Access Compliance Report

Public Rights-of-Way

Intersection ID: 50401	Main Street: DEBORAH_DR	Cross Street: WILSON_DR	Location:	E
ADA ID: 74B35241C0D5	Ramp Type: Perp	Initial Pass/Fail: Fail	Overall Compliance: No	Severity Score: 22.5
Codes/Mitigation Info/Possible Solution		Field Measurements/Component Compliance

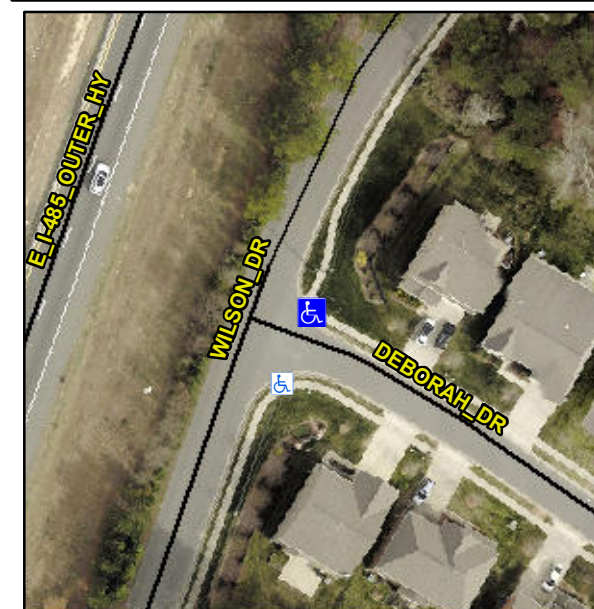
Not Found, R304.5.1, R304.2.2, R304.5.3

Compliance	Description	Data	Compliance	Description	Data
N/A	Ramp Length (in)	79.0	No	Ramp Slope (%)	9.5
No	Ramp Width (in)	47.5	No	Ramp XSlope (%)	2.6
N/A	Flare Type LT	N/A	N/A	Flare Type RT	N/A
N/A	Flare Slope LT (%)	N/A	N/A	Flare Slope RT (%)	N/A
N/A	Flare Traversable LT?	N/A	N/A	Flare Traversable RT?	N/A
N/A	Landing Length (in)	N/A	N/A	DWS Provided?	N/A
N/A	Landing Width (in)	N/A	N/A	DWS Contrast?	N/A
N/A	Landing Slope (%)	N/A	N/A	DWS Length (in)	N/A
N/A	Landing X Slope (%)	N/A	N/A	DWS Full Width?	N/A
N/A	Landing Curb? (Y/N)	N/A	N/A	DWS Offset (in)	N/A
N/A	Shared Landing?	N/A			
N/A	Gutter Ponding?	N/A	N/A	Gutter Slope (%)	N/A
N/A	Gutter Lip Ht (in)	N/A	N/A	Gutter X Slope (%)	N/A
N/A	Painted X Walk1?	No	N/A	Painted X Walk2?	N/A
	X Walk 1 Direction	To SW		X Walk 2 Direction	N/A
N/A	X Walk 1 Width (in)	N/A	N/A	X Walk 2 Width (in)	N/A
	X Walk 1 Slope (%)	0.3		X Walk 2 Slope (%)	N/A
	X Walk 1 X Slope (%)	3.4		X Walk 2 X Slope (%)	N/A

Remove & Replace Entire Ramp.
